CITY OF ALBUQUERQUE

**RE: Sawmill Market
1909 Bellamah NW
Grading and Drainage Plan
Engineer's Stamp Date: 10/22/18
Hydrology File: J13D017A**

Based on the submittal received on 10/23/18, the Grading and Drainage Plan cannot be approved for Building Permit and SO-19 Permit until the following corrections are made:

Sheet Title:
PROPOSED
DRAINAGE
PLAN

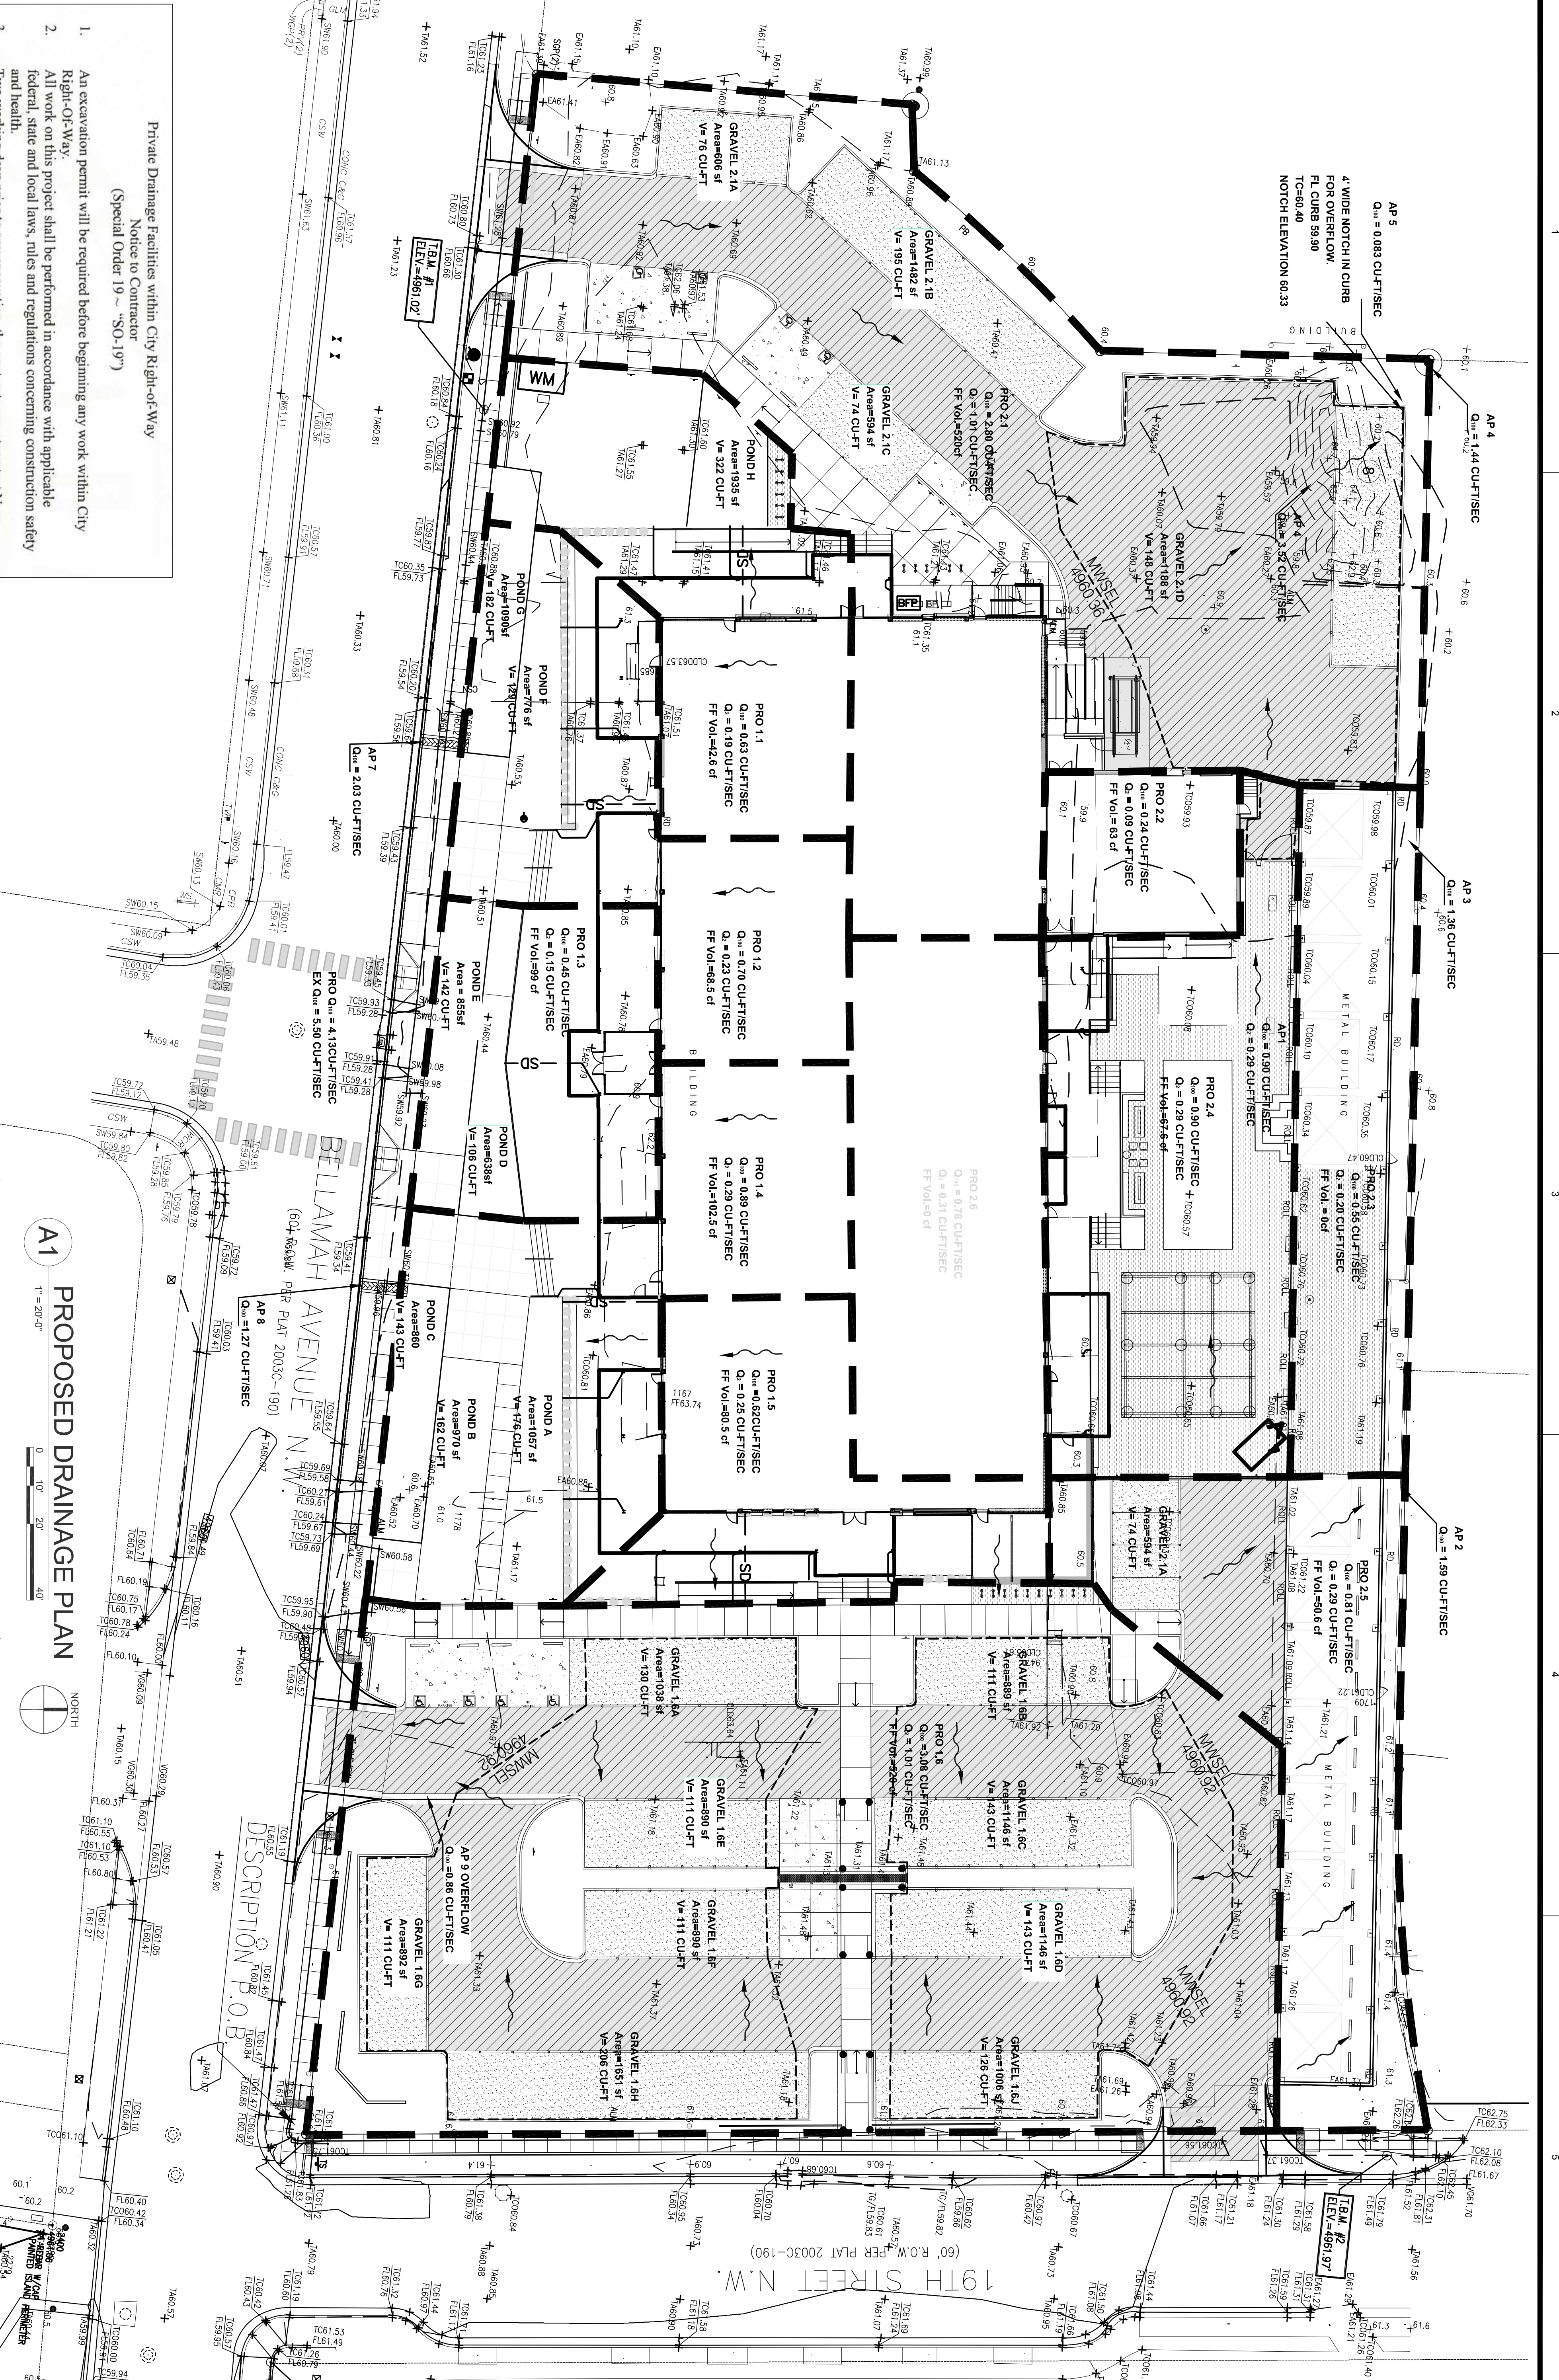
1. The ponds described on the drainage plan need to be shown on the grading plan, supported with top of pond elevations, and bottom of pond elevations.
2. Build notes for the areas of new paving, paving to remain, gravel-pave, and concrete work also need to be provided on the grading plan. Alternatively, if a separate paving plan was prepared to describe this work, please provide it.
3. Provide/show waterblocks on the NE and SE curb cuts. The spot elevation should show the maximum height, flowline in the public road, and show that the paved drive aisles slope back from the high point to retain the first flush volume. Please include the finished floor elevation of the building(s) and make sure the waterblocks will overtop first in the event they need to be used as an emergency overflow.
4. Provide a section/detail on the grading (or paving) plan for the gravel-pave parking/ponds.
